802.1ASbt presentation on Short Sync Interval issue for Clause 10 (Media Independent layer)

Bob Noseworthy (ren@iol.unh.edu)
University of New Hampshire's
InterOperability Laboratory (UNH-IOL)
IEEE 802.1 TSN TG
2014.05.15

The PortSyncSyncSend SM (Fig 10-8 per 802.1AS-cor)

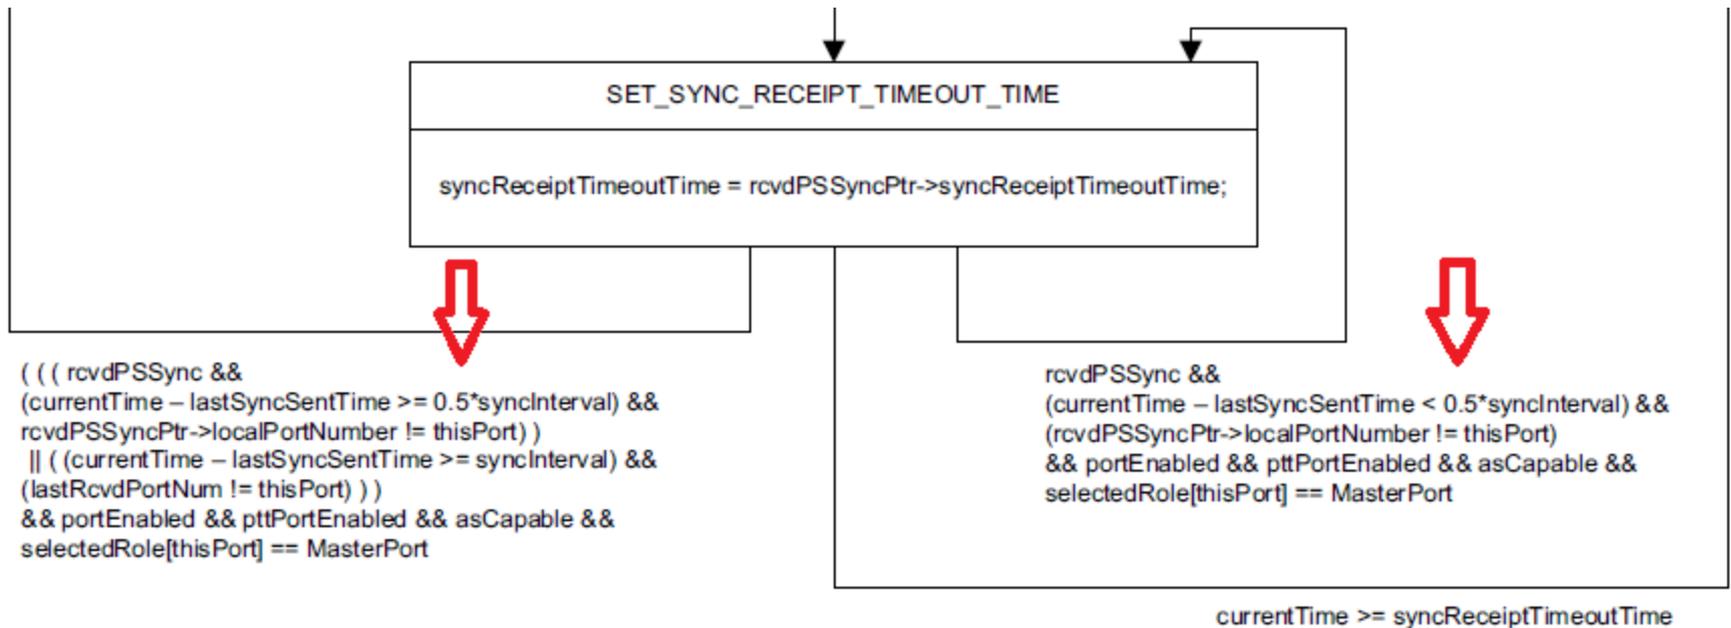
- Focus is on the left branch:
 - “currentTime- lastSyncSentTime >= 0.5*syncInterval”
- VS
- the “currentTime – lastSyncSentTime >= syncInterval”.

```
( ( ( rcvdPSSync &&  
(currentTime – lastSyncSentTime >= 0.5*syncInterval) &&  
rcvdPSSyncPtr->localPortNumber != thisPort) )

|| ( (currentTime – lastSyncSentTime >= syncInterval) &&

(lastRcvdPortNum != thisPort) ) )  
&& portEnabled && pttPortEnabled && asCapable &&  
selectedRole[thisPort] == MasterPort
```

- In the first expression ($0.5 * \text{syncInterval}$) would eval to TRUE if a rcvdPSSync came in before the local stations syncInterval timer expired.
 - This is true either:
 - if the device is a bridge that is not GM, thus receiving Sync's from upstream at a different rate than the local syncInterval timer
 - If the device is generating sync messages internally but via a process that is not synchronized with the PortSyncSync SM's syncInterval timer

- If +/-30% were used, then the expression could be modified to:
- ```
(((rcvdPSSync &&
(currentTime – lastSyncSentTime >= 0.7*syncInterval) &&
rcvdPSSyncPtr->localPortNumber != thisPort))

|| ((currentTime – lastSyncSentTime >= 1.3*syncInterval) &&

(lastRcvdPortNum != thisPort)))
&& portEnabled && pttPortEnabled && asCapable &&
selectedRole[thisPort] == MasterPort
```
- With a similar change on the looping transition into the SET\_SYNC\_RECEIPT\_TIMEOUT\_TIME state (change the 0.5\* there to 0.7\*)
